THE FACTORY

APRIL 2021

PLANNING DRAWINGS

FACTORY MANCHESTER

1 WEST ELEVATION
SCALE: 1:200

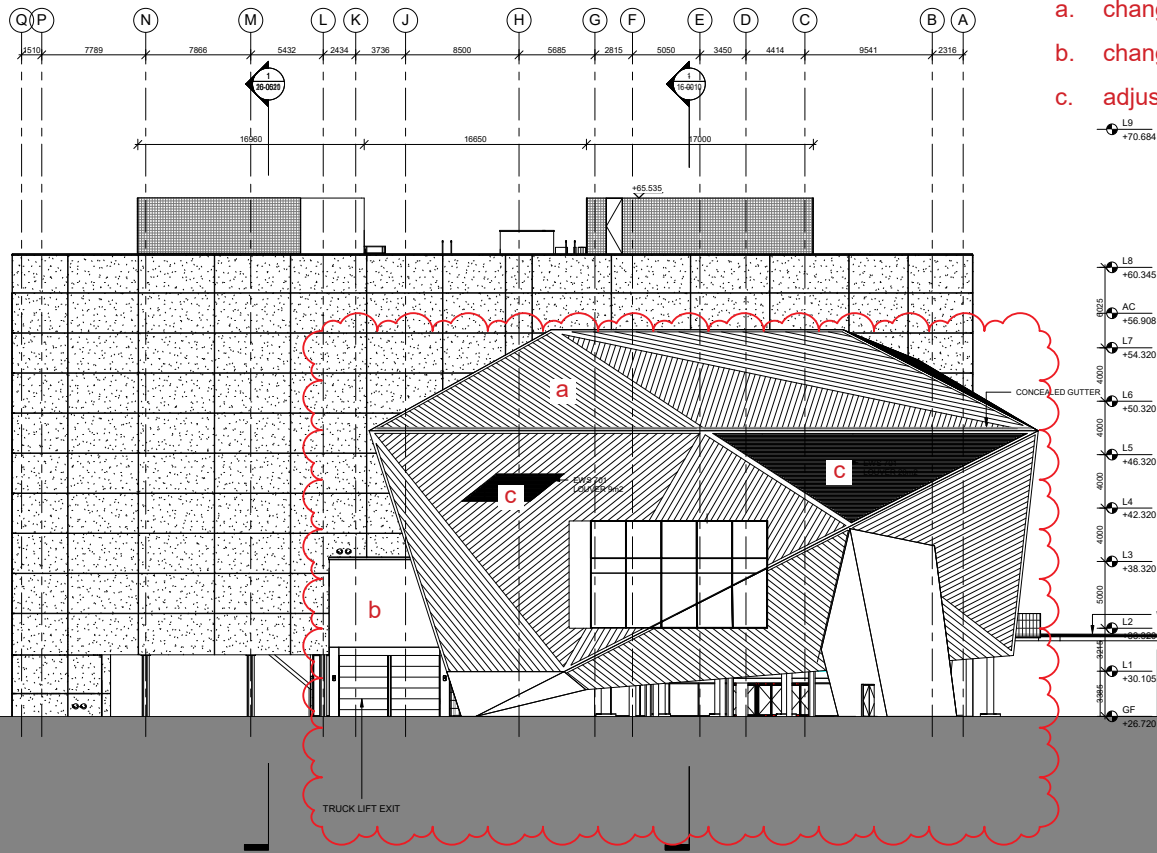
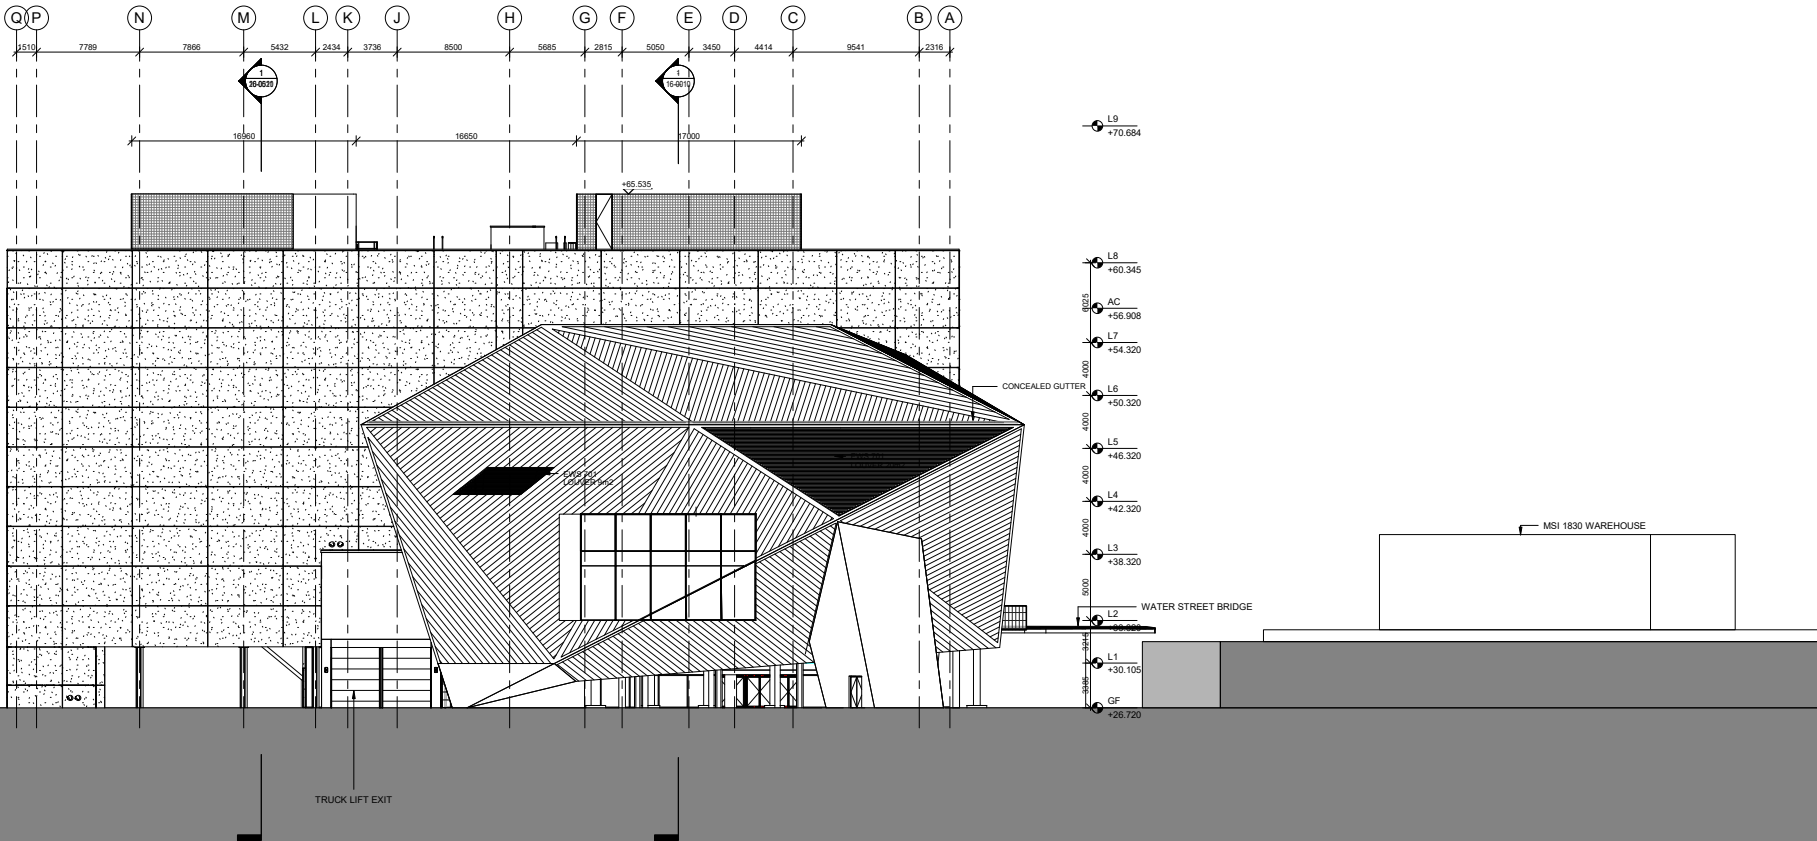
- a. change to cladding type at theatre from single-ply to standing seam
- b. change to cladding of trucklift from expanded metal mesh to cast in place concrete
- c. adjusted louvre shape, location
